BY JOHNSON CONTROLS

SI0247

Equipment Affected: YK, YS, YT, YIA, YPC

1 X 40 Single Line Micropanel Vacuum Fluorescent Display Replacement

FIGURE 1 - MODIFICATION OF ISOLATION BOARD

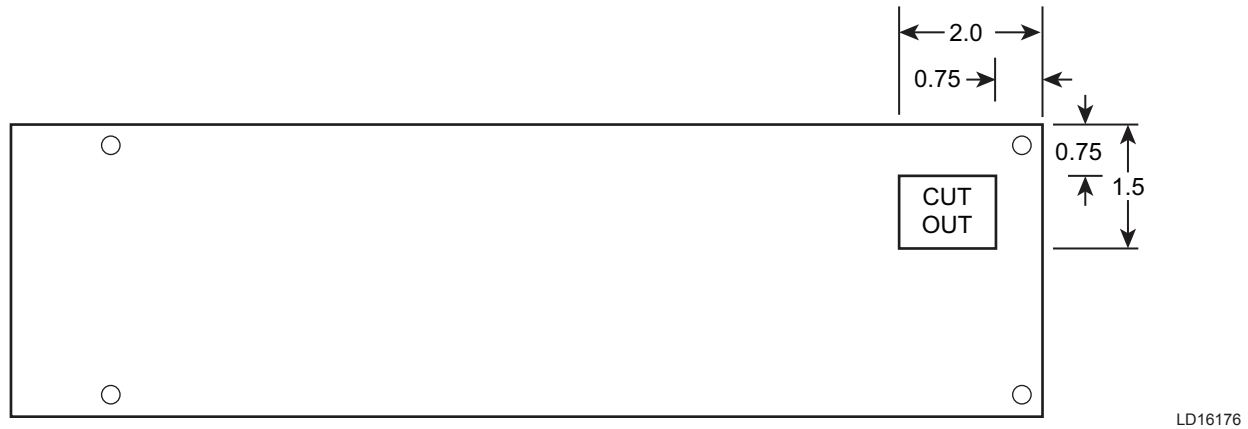
If your old display has an isolation board mounted on it, modify the isolation board by cutting a hole as shown In Figure 1.

7. Place the isolation board on the new display and install the new display using the 4 mounting screws.
8. Connect the 6 pin power connector to the display connector J5.
9. Connect the display ribbon cable to the display connector J2. (Ensure that the colored band on the ribbon cable is located on the top, aligning with pin 1 of J2)
10. Note that nothing is connected to J1 or the connector next to it.
11. Turn power back on to the chiller.
